AR8600 Bulletin Page

Failure of IC410 - over-voltage (early AR8600 MK1)

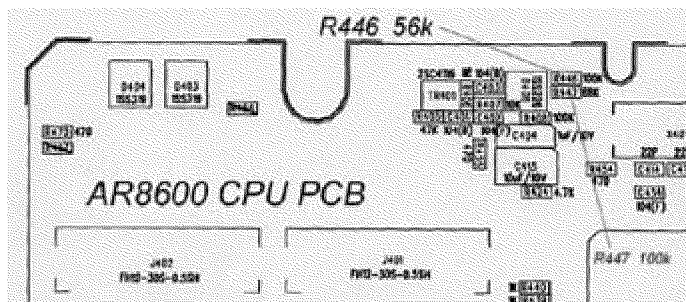
In both cases, the voltage regulator on the CPU PCB **IC410** (TK11245) had failed, which in

turn had damaged the EEPROM memory store **IC402** (AT29C512) on the same PCB. This resulted in spurious behaviour and the inability to change memory contents.

Both components had to be replaced, and it is suggested (by AOR Japan, the equipment manufacturer) that two additional diodes (1N4148 or 1SS1588 or 1SS266) are inserted in series with the un-switched 12V line between connector J403 and the regulator IC410... this is best achieved by a cut in the track between the unused +ve pad of C426 en-route IC410. It is likely that the 'system data' may need to be reinstated after component replacement, using a modified version of the EM8200 slot card (referred to as an AR8600 workshop tool).

Additional series diodes have been fitted to all new stock equipment in recent months to increase robustness of the power supply circuit (for occasions where an over-volt connection is encountered).
